MODIFICATION INSTRUCTIONS

***KODAK X-Omatic* MULTILOADER 700**

MODIFICATION No. 25

To avoid excessive vibrations of the OPENER SHAFT.

figure 1

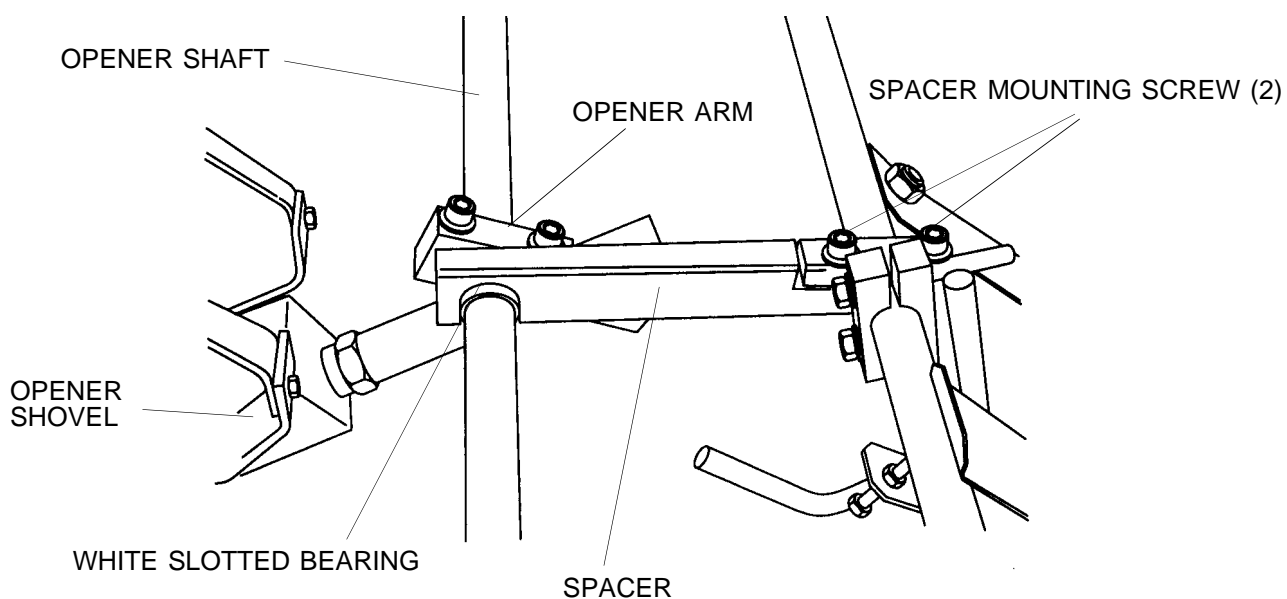
1. Switch off the ML700.
2. Open the TOP COVER.
3. Mount the SPACER at the front SHAFT as shown below. Do not tighten the MOUNTING SCREWS at this time. Ensure that the OPENER ARM does not touch the SPACER.

figure 2

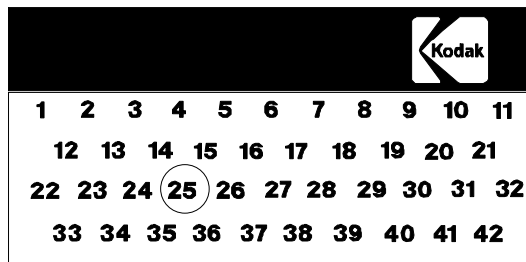
4. Slide the WHITE SLOTTED BEARING on the OPENER SHAFT. The BEARING FLANGE should be to the side of the OPENER SHAFT. If the FLANGE is to the other side, the BEARING might slide out.
5. Ensure that the round cut-out of the SPACER rests fully on the WHITE SLOTTED BEARING and fasten the SPACER MOUNTING SCREWS.
